UNITED STATES PATENT AND TRADEMARK OFFICE

10/797,839

Office Action Summary	Application No. 10/797,839	Applicant(s) BLAKE ET AL.	
	Examiner GERALD W. MCCLAIN	Art Unit 3653

DETAILED ACTION

FIG. G1

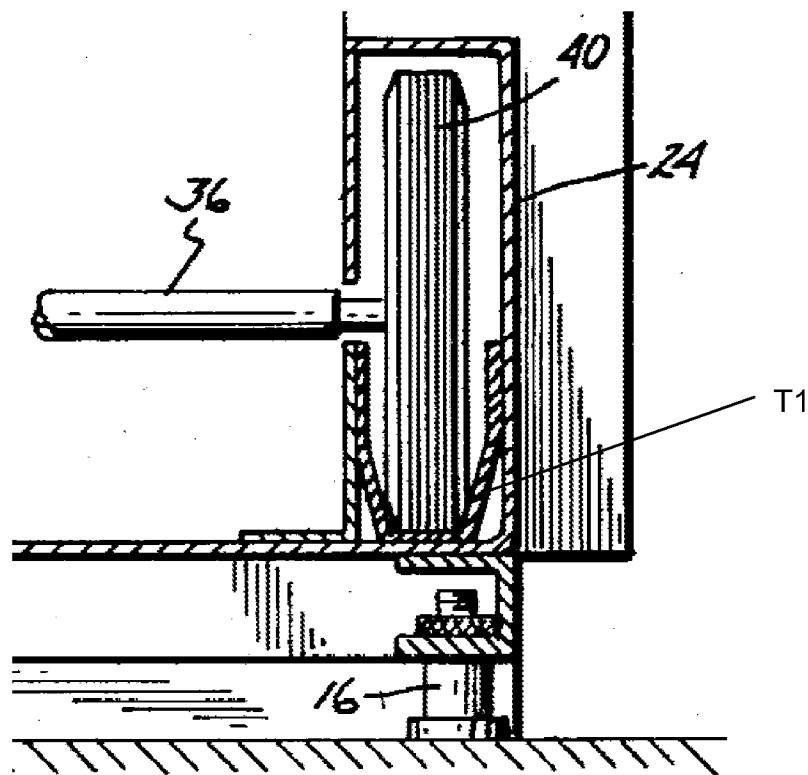
Muellner shows a similar device having a track (see FIG. G1 below, T1) for the purpose of receiving and capturing the casters (column 2, lines 57-66). Therefore, it would have been obvious to a person having ordinary skill in the art at the time the invention to modify Hino as taught by Muellner and include Muellner's similar device having a track for the purpose of receiving and capturing the casters.

Muellner shows a similar device having a track (see FIG. G1 below, T1) for the purpose of receiving and capturing the casters (column 2, lines 57-66). Therefore, it would have been obvious to a person having ordinary skill in the art at the time the invention to modify Hino as taught by Muellner and include Muellner's similar device having a track for the purpose of receiving and capturing the casters.

Muellner shows a similar device having a track (T1 above) for the purpose of receiving and capturing the casters (column 2, lines 57-66). Therefore, it would have been obvious to a person having ordinary skill in the art at the time the invention to modify Hino as taught by Muellner and include Muellner's similar device having a track for the purpose of receiving and capturing the casters.

Regarding the track T1 above, note that it is applied directly under the wheels of Hino. Therefore, 122 is directly over the track and wheels (See FIG. 3 of Hino, 122).
